WARRANTY BULLETIN

Campaign no.: 2013-0015
2013-0016

Subject: **Spyder™**

No. **2013-9**

1. Old fuse box cover
2. New fuse box cover

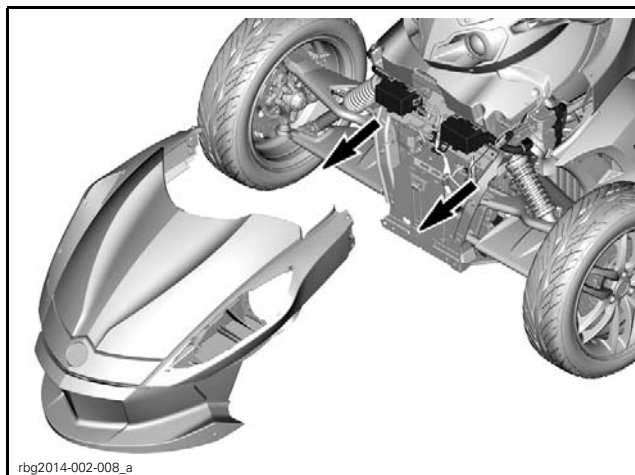
Water may infiltrate either of the front fuse boxes. The source of the infiltration may be:

1. The fuse box cover.
2. The bus-bar connection behind fuse box
3. Any of the wire splices behind fuse box.

1. Replace the fuse box covers.
2. Apply liquid tape around base of bus-bar.
3. Apply liquid tape into and around all splices behind fuse boxes.

1. Remove old covers.

2. Transfer fuses to new covers.

TYPICAL LIQUID TAPE APPLICATION

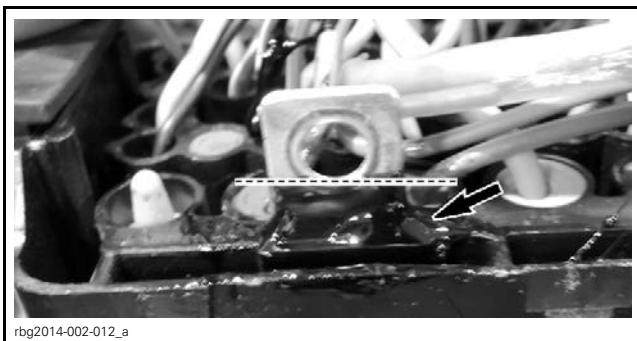
5. Seal both ends of all the wire splices with liquid tape.

NOTE: Extend liquid tape onto wires and push the liquid tape into both ends of the splice for a good seal.
